Model type:
TAN2FR

Commercial code:
F035361

51420c0 Exploded views

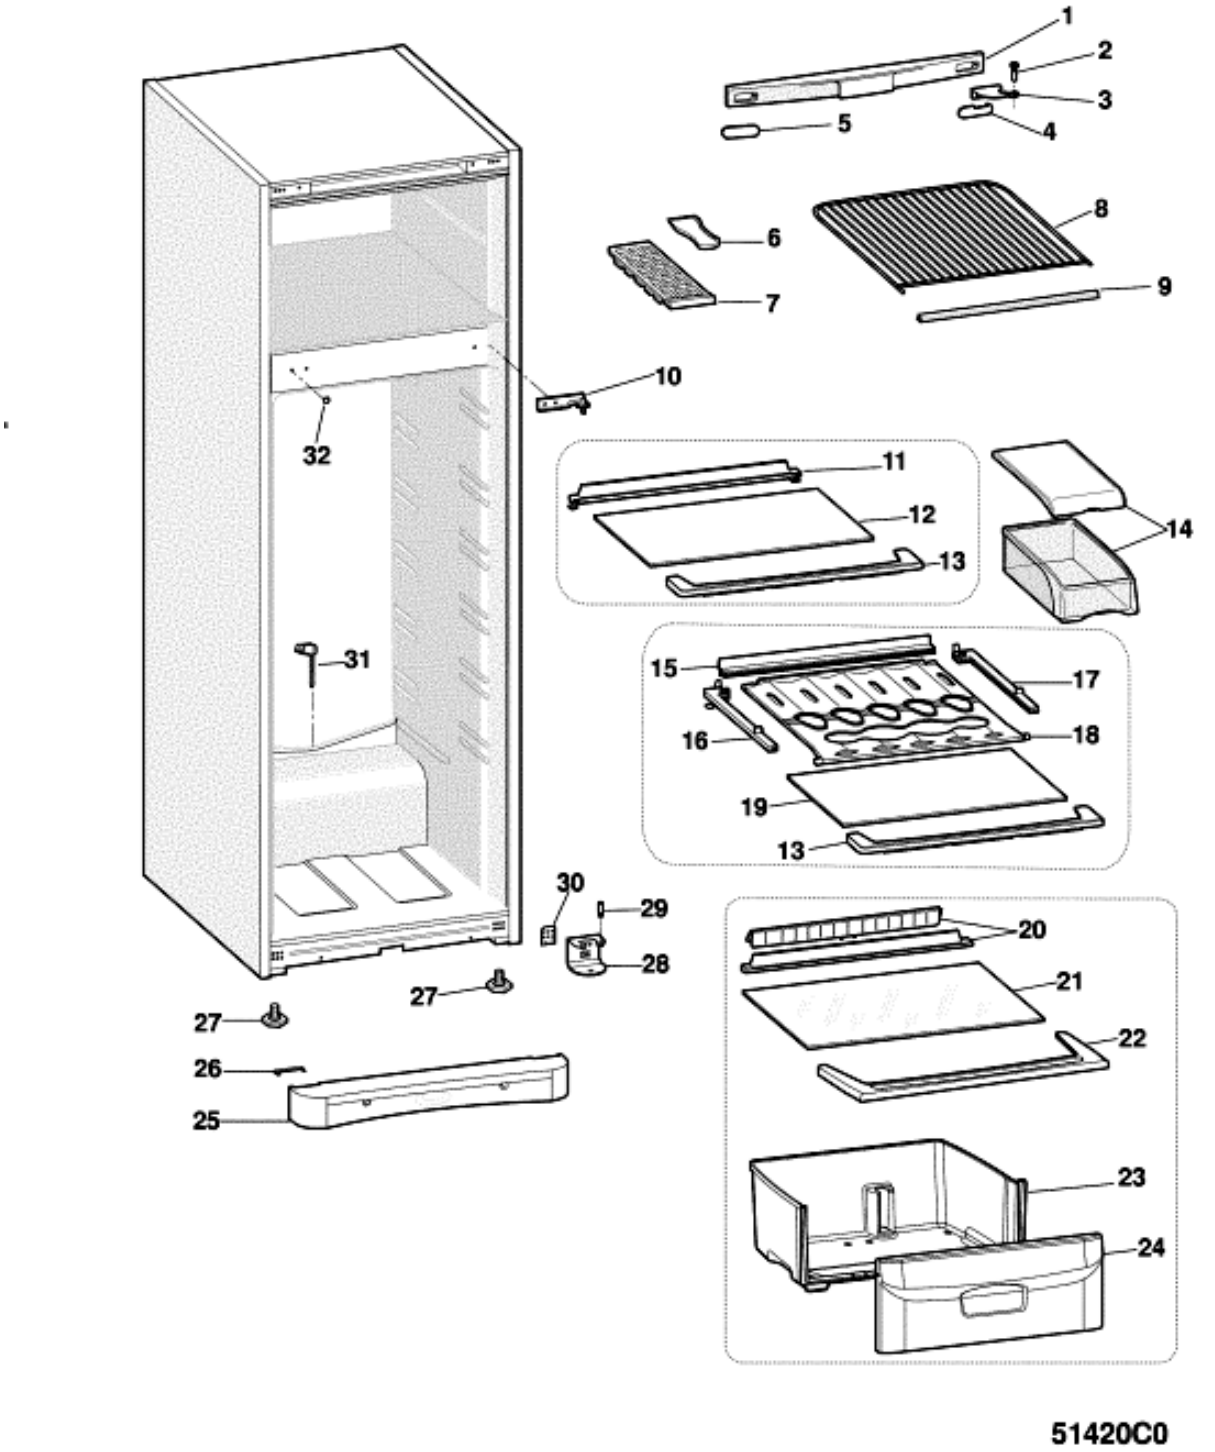
n2510j00: SUBSTITUTION LOWER HINGE PIN

In order to make better the assembly and to prevent an accidental unscrewing of lower hinge pin with consequent falling down of the door, original pin has been substituted by another one longer.

In the course of the time more than one pin has been tested, therefore the history of the substitutions is reported:

C00017658 (13.5mm) --> C00259768 (21mm) --> C00281425 (23mm)

For quality issues on interested models is managed only the last one C00281425 (23mm).

51421m0 Exploded views

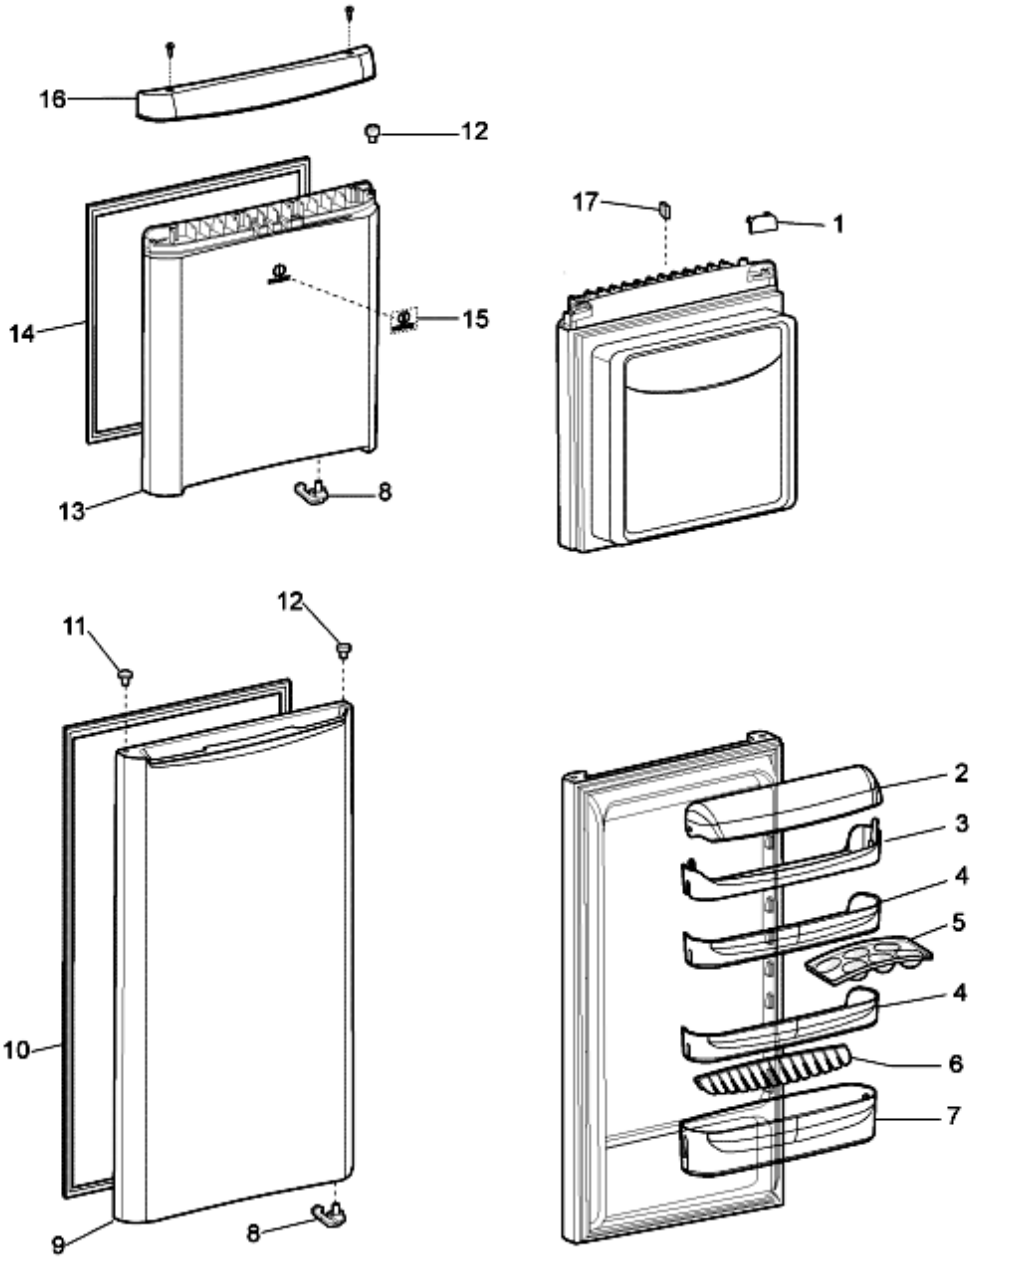
n2511b02: ELIMINATION COVER FOR UPPER DOOR SHELF-INTERNAL ACCESSORIES RESTYLING

Cover for upper door shelf has been eliminated. The upper door shelf has been standardized with the middle one. Subsequently has been standardized with transparent internal accessories instead of those in light blue colour once stock has depleted.

5142260 Exploded views

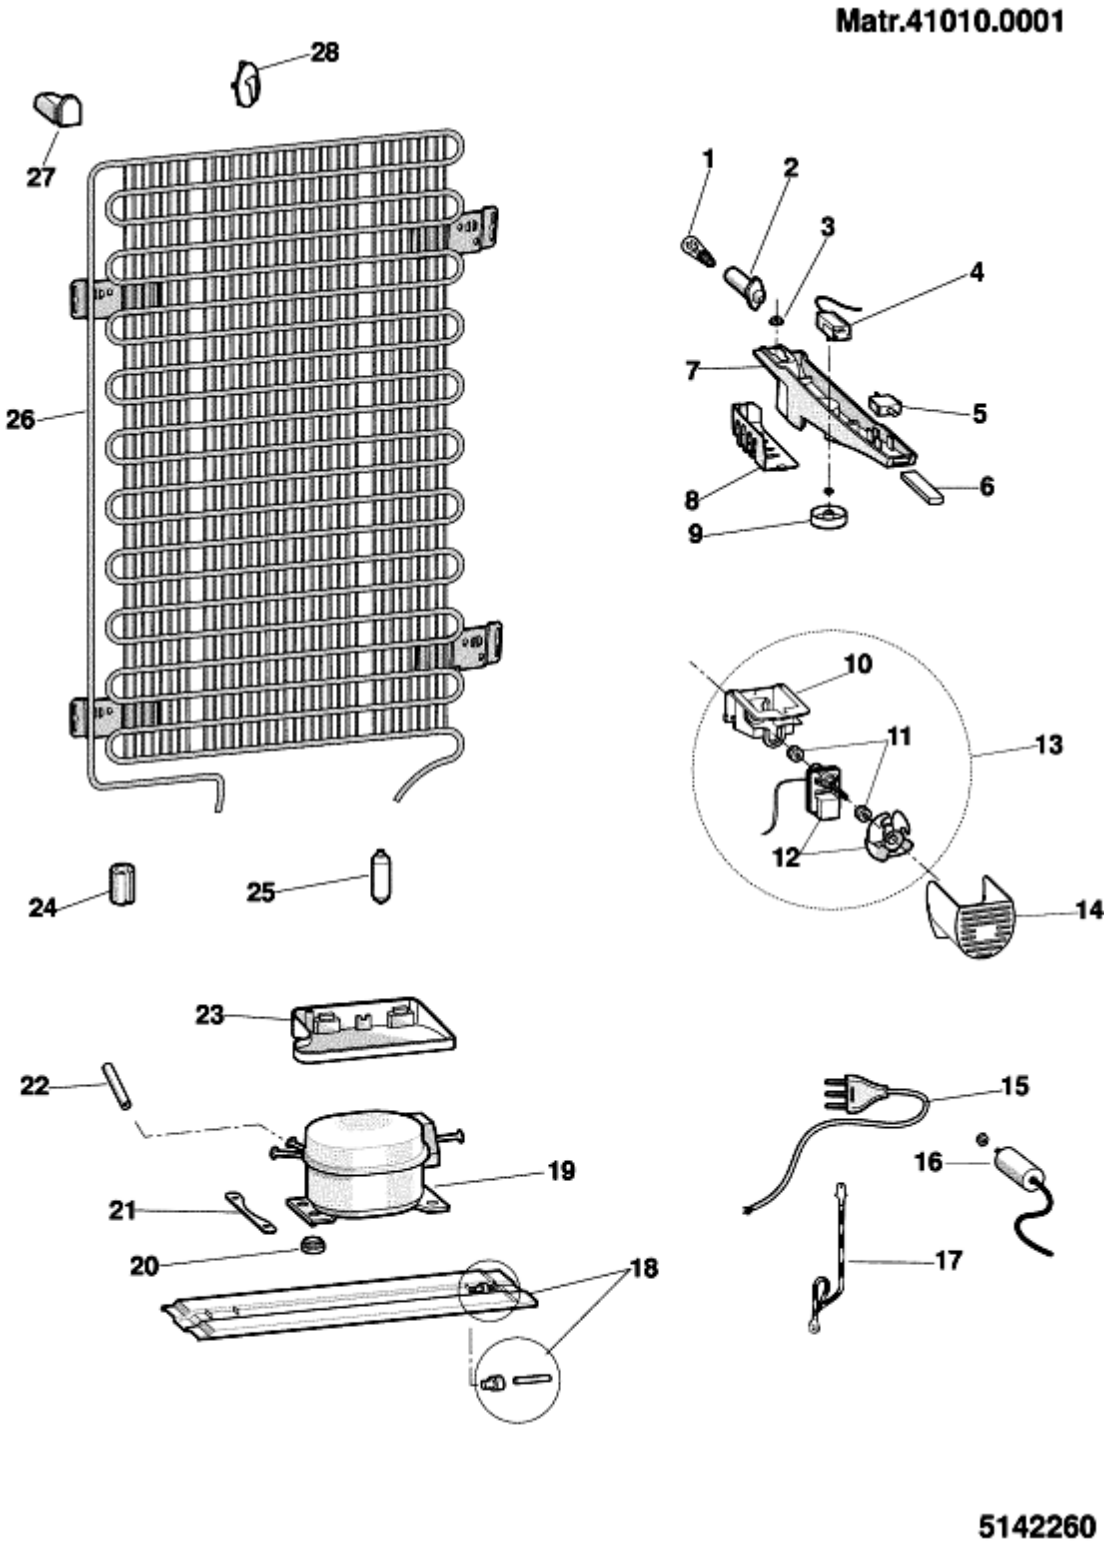
n1025135: Thermostat box on Indesit/Ariston Opera-60 refrigerators (low A.T. +16°C)

As of July 2003, two new "Low ambient temperature thermostat box kits" have been introduced as spare parts for Ariston Opera-60 and Indesit 2000 - 2002 - 2003 range refrigerators with Giugiaro thermostat box (075646).

The two kits have a different thermostat (remember to always check the position of the mark).

The kit must only be used to solve freezer performance problems caused by an ambient temperature below +16° C.
This innovative kit features a DIODE, activated by means of the luminous switch, which makes the thermostat box lamp turn on.
It must be activated when the ambient temperature falls below +13°C (closed contacts: see the wiring diagram that comes with the kit).
The heat produced by the lamp activates the thermostat, thus ensuring regular operation of the appliance.
When replacing the thermostat box, no component can be reused (including the wiring).
The kit wiring has pin terminals for connection to the terminal block on the compressor; some modifications may be required for other solutions.
Given below is the list of kit items available as spare parts:
